Government of the People's Republic of Bangladesh
Prime Minister's Office
Bangladesh Economic Zones Authority (BEZA)
Bangabandhu Sheikh Mujib Shilpa Nagar (BSMSN) Development Project
Bangladesh PRIDE (P 170688)
Biniyog Bhaban (Level 7,8,9), Plot#E-6/B, W Agargaon, Dhaka 1207, Bangladesh
www.beza.gov.bd

Subject: Clarification of Pre-bid meeting of 'Security and support amenities (seaside), WD 10A-BSMSN-BEZA'.

Pre-bid meeting minutes of 'Security and support amenities (Sea side), WD 10A-BSMSN- BEZA'

TYPICAL GRILL DETAILS

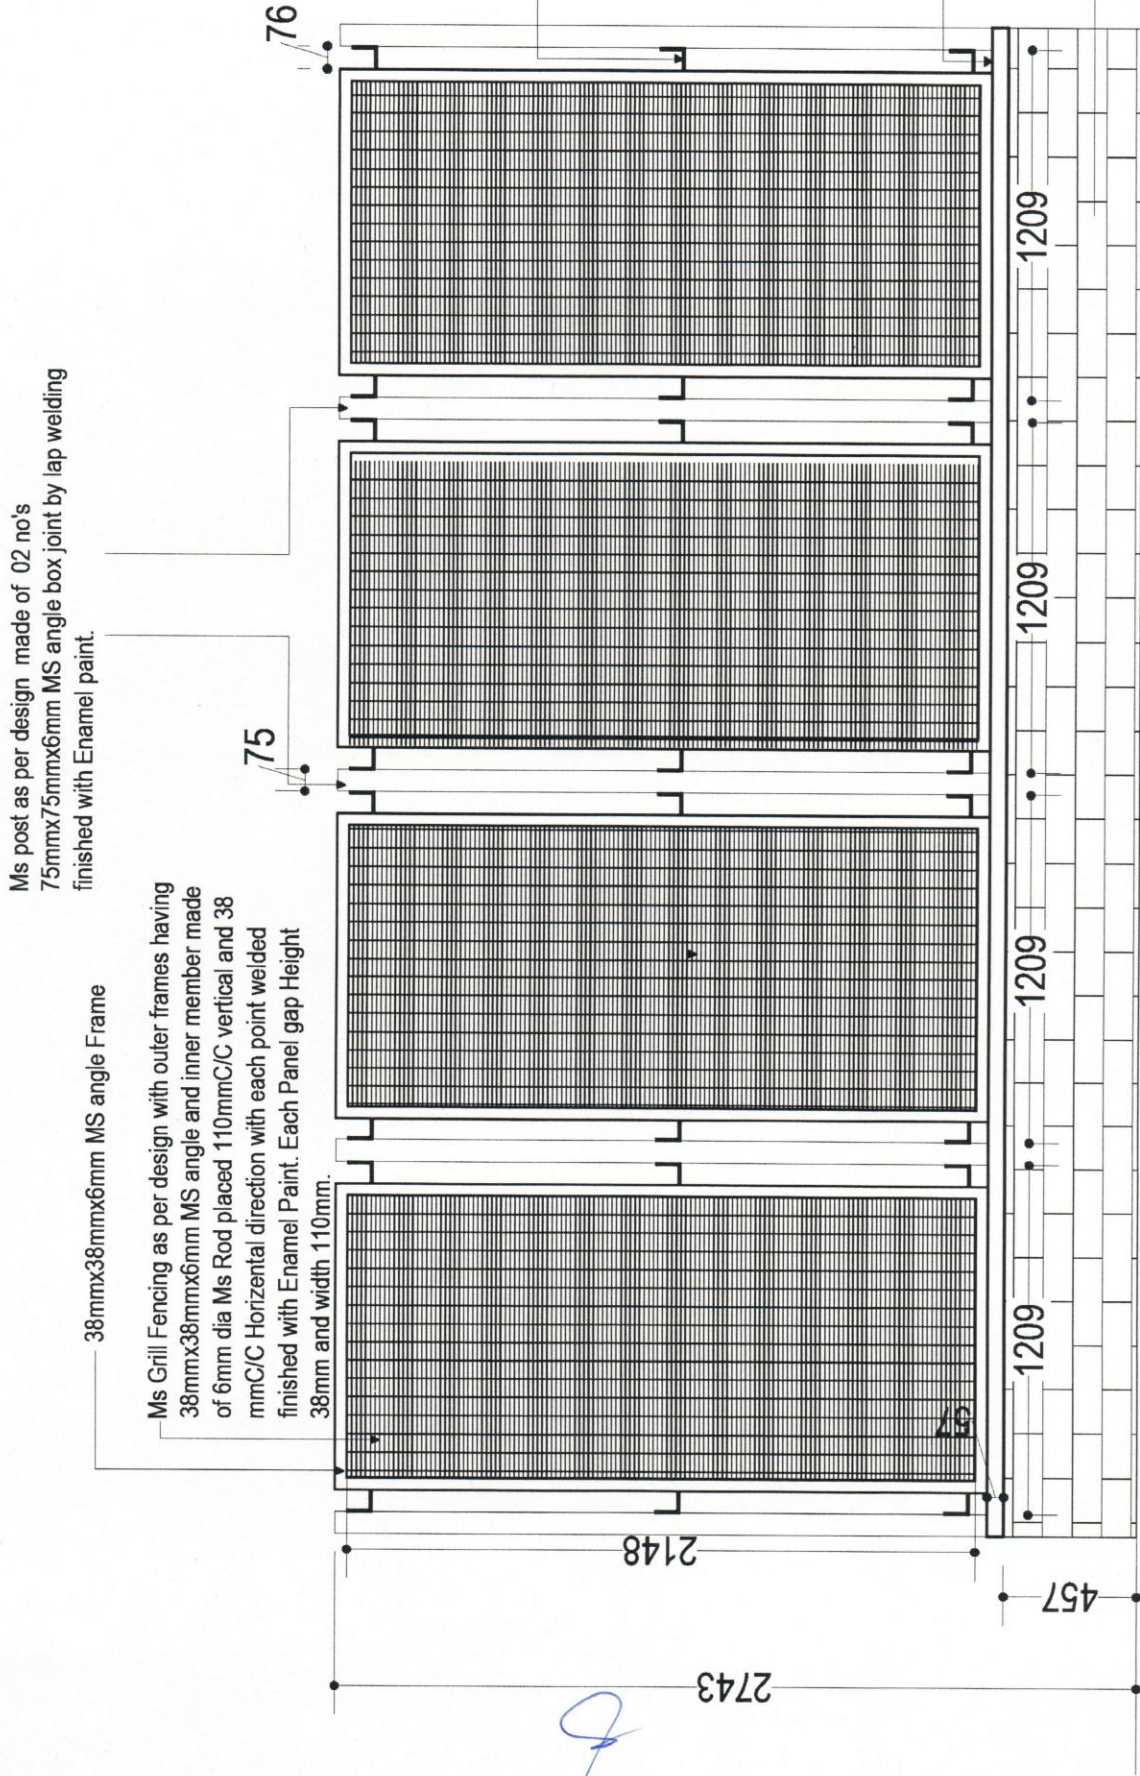
4.	<p>BOQ page no 199, Item no. 19, unit is sqm, Qty.42052.581, Inner members having 6 mm dia M.S rod placed @ 110 mm c/c vertical direction and @ 38 mm c/c in horizontal direction and also in the specification page no 440 in the drawing no A- 01& A-02 it is mentioned as 6 mm dia M.S rod placed @ 38 mm c/c vertical direction and @ 110 mm c/c in horizontal direction.</p> <p>- Please confirm which one is correct.</p>	<p>Please follow each gap Height of 38mm and Width 110mm for 6mm rod. Please follow the attached drawing as Annex-1.</p>

Ms Grill Fencing as per design with outer frames having
38mmx38mmx6mm MS angle and inner member made
of 6mm dia Ms Rod placed 110mmC/C vertical and 38
mmC/C Horizontal direction with each point welded
finished with Enamel Paint. Each Panel gap Height
38mm and width 110mm.

ELEVATION OF GUARD ROOM

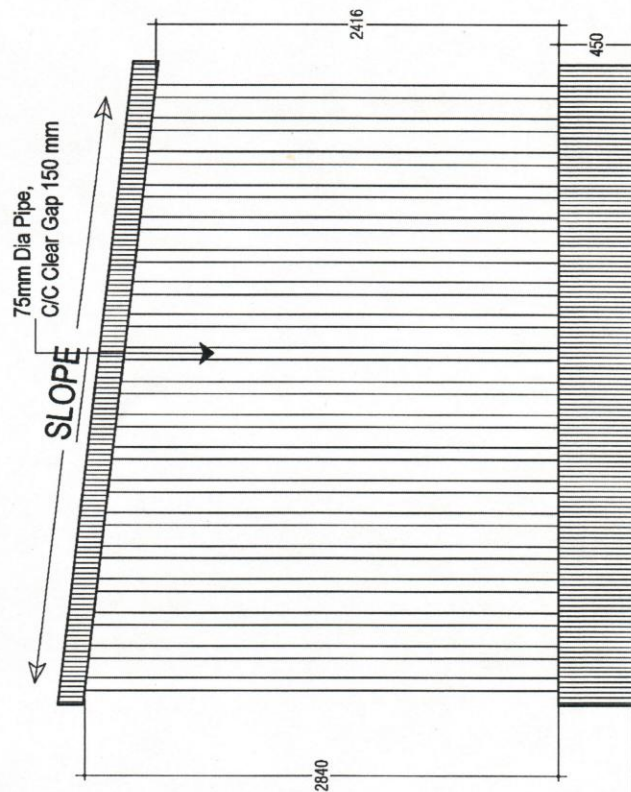
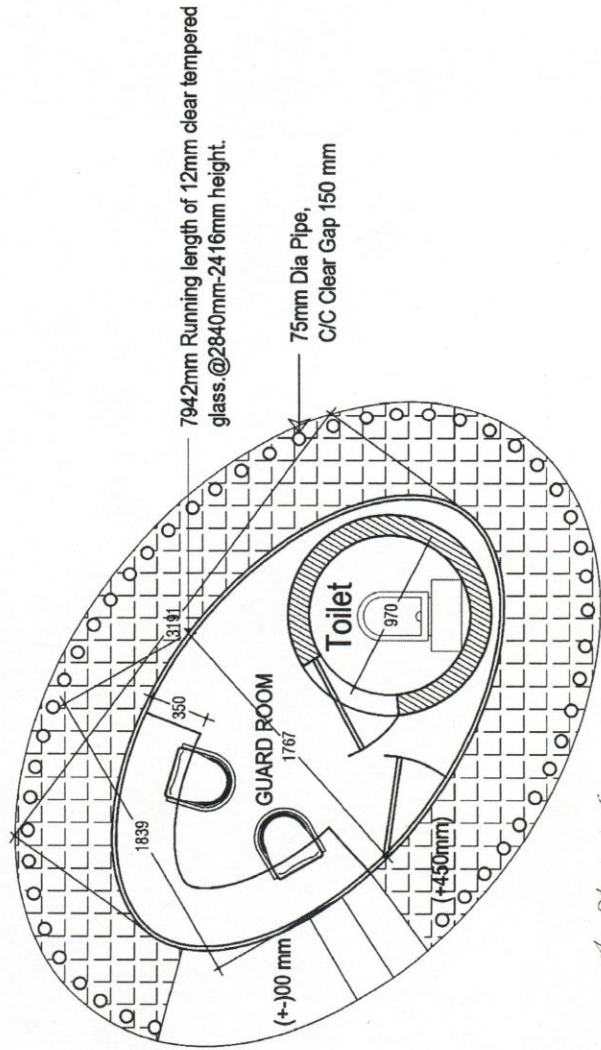
Sl. No.	Query raised	Clarifications provided
5.	<p>Construction of guard room, BOQ page no. 250, item no. 17, Supply, fittings and fixing of 12 mm thick clear tempered glass wall up to 3.00 meter height.</p> <p>As per direction of Engineer in- charge. Unit is in square meter.</p> <p>-This item drawing is not available in the document. Please provide.</p>	<p>The Glass area and height range will be 2840mm (Max height) to 2416mm (Minimum Height) with 7492mm Running length. Drawing is attached herewith as <u>Annex-2</u>.</p>
